**APPENDIX RTC-1**  
**PUBLIC COMMENT LETTERS RECEIVED ON DRAFT EIR**

Subject: **Sloughhouse Solar Facility / EIR / 2021100444**

Photo Viewpoint KOP 4. Looking Northeast from Simpson Ranch Court

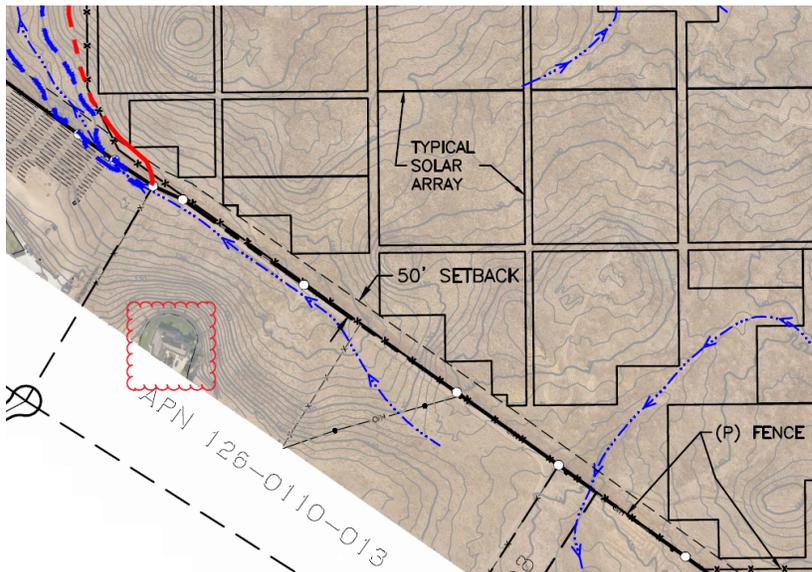
- 1. Visual Aesthetics.** The Draft EIR, pr 115 notes *“Under CEQA, an evaluation of a project’s potential visual change as viewed from private property is not required. Nevertheless, for purposes of full disclosure, the project applicant has elected to provide a comparison of a viewshed change from the surrounding private residences.”* And, *“The change in visual character of the foreground and middleground views from these two residences at 12500 and 12501 Simpson Ranch Court to the north would represent a substantial degradation of the existing visual character.”*  
As such, Mr. Grossglauser is concerned about the loss of views, glint, and glare as this property is on a knoll that would overlook several hundred acres of the north adjacent solar array.

- 2. Glare Monitoring.** Is there any way to monitor compliance for the Glare Analysis?
- 3. Landscape Screening.** The proposed landscape screening is along the public RoW of Dillard and Meiss Roads. Given the above reference to *substantial degradation of the existing visual character* for the two properties 12500 and 12501 Simpson Ranch Court, would there be any consideration of additional landscaping in the triangular gap spaces between the arrays and the 50-ft setback?
